WOLF CREEK

Subject: Docket No. 50-482: Proposed Revision to Technical
Specification 3/4.3, Changes to ESFAS Functional Units 6.f,
8.a, and 8.b

ATTACHMENT I
SAFETY EVALUATION

Figure 1

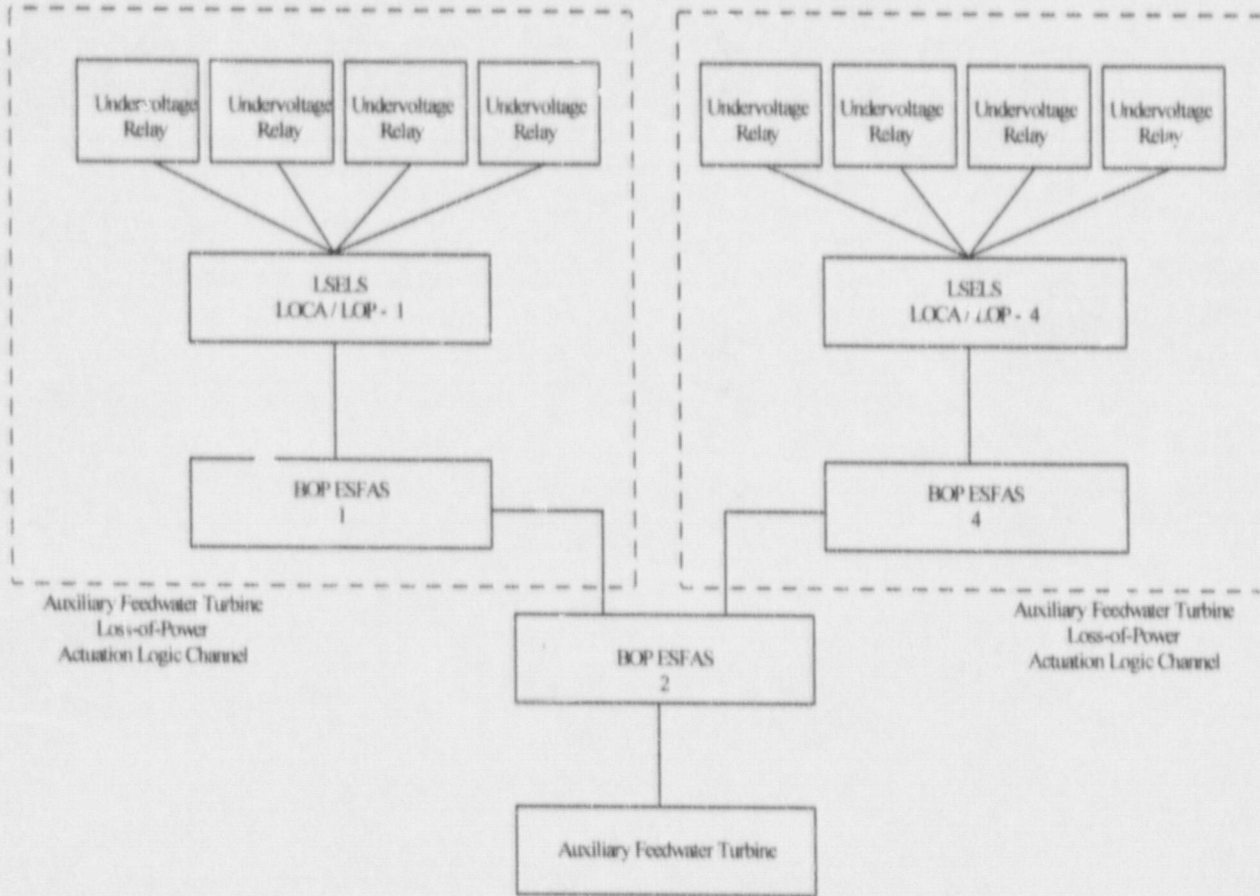
A loss of offsite power (LOP) is indicated by the under-voltage relays detecting a loss of voltage on each ESF bus, as discussed above. Upon satisfying the two-out-of-four loss of voltage logic in the LSELS cabinets, LSELS output relays feed the redundant separation groups 1 and 4 BOP-ESFAS cabinets as shown in Figure 1. The separation groups 1 and 4 BOP-ESFAS cabinets perform several functions, as discussed above, but on a LOP signal these cabinets perform only two functions, i.e., the steam generator blowdown and sample lines are isolated and electrically isolated outputs are provided to the separation group 2 BOP-ESFAS cabinet. The separation group 2 BOP-ESFAS cabinet is only associated with the TDAFW pump and is considered to be part of that end device, i.e., the TDAFW pump, in the Technical Specifications. On a LOP signal, the turbine steam supply valves (ABHV0005 and ABHV0006) and the turbine trip and throttle valve (FCHV0312) are opened for the start of the TDAFW pump.

The digital portion, labeled new Functional Unit 6.f.2), consists of the output relays from the load shedder and emergency load sequencer (LSELS) cabinets and that portion of the BOP-ESFAS separation group 1, 2 and 4

circuitry associated with the start of the TDAFW pump upon a loss of offsite power. A new ACTION Statement 30 has been added which recognizes that this digital circuitry is only associated with the TDAFW pump. As such, the inoperability of one logic train would be given a 48 hour AOT after which the TDAFW pump would be declared inoperable and ACTION would be taken as required by Technical Specification 3.7.1.2. The 48 hour AOT is a reasonable restoration time considering the nature of this Functional Unit and the available redundancy. The 48 hour AOT is also consistent with that allowed by the current ACTION Statement 22 for Functional Unit 6.f, as well as the AOT allowed by ACTION Statements for other automatically initiated functions (e.g., ACTION Statement 5.a for Reactor Trip System Functional Unit 6.b and ACTION Statement 26 for ESFAS Functional Unit 9). If both logic trains were inoperable, new ACTION Statement 30 would require that the TDAFW pump be immediately declared inoperable. There would be no requirement to enter Specification 3.0.3 for loss of both logic trains since the only affected end device is the TDAFW pump and ACTIONS already exist under Specification 3.7.1.2 to address TDAFW pump inoperability. Similar approaches addressing end device OPERABILITY are also used for ESFAS Functional Units 3.c (ACTION Statement 17), 6.a (ACTION Statement 24), and 10 (ACTION Statement 25).
